DOWNTOWN CARPARK SITE DEVELOPMENT - CONDITIONS OF CONSENT

BUN60460864, LUC60460865, DIS60460866 and WAT60460867

Highlighted comments = Response by Precinct to changes to conditions proposed by Auckland Council that are not matters addressed by Auckland Transport (relating to construction traffic) in the Joint Statement and are not otherwise agreed and include in the updated conditions.

ATTACHMENT 3: VIADUCT STREETS

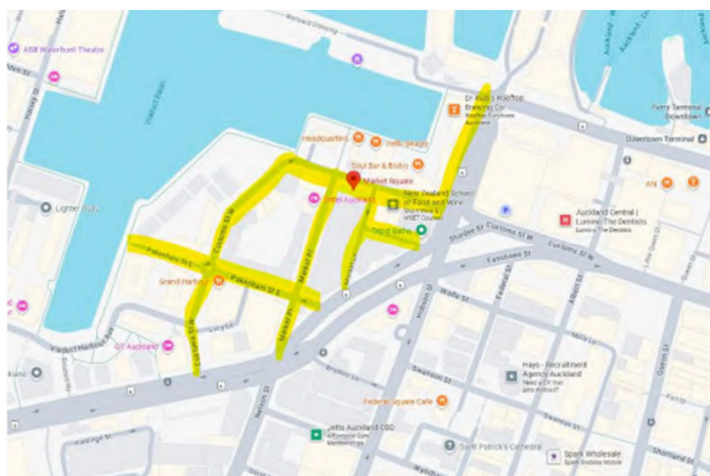
This is added with reference to the comments made within the Council's s53 Response, the cover letter provided with these condition comments and having regard to **Comments NS3** of the Auckland Transport condition comments.
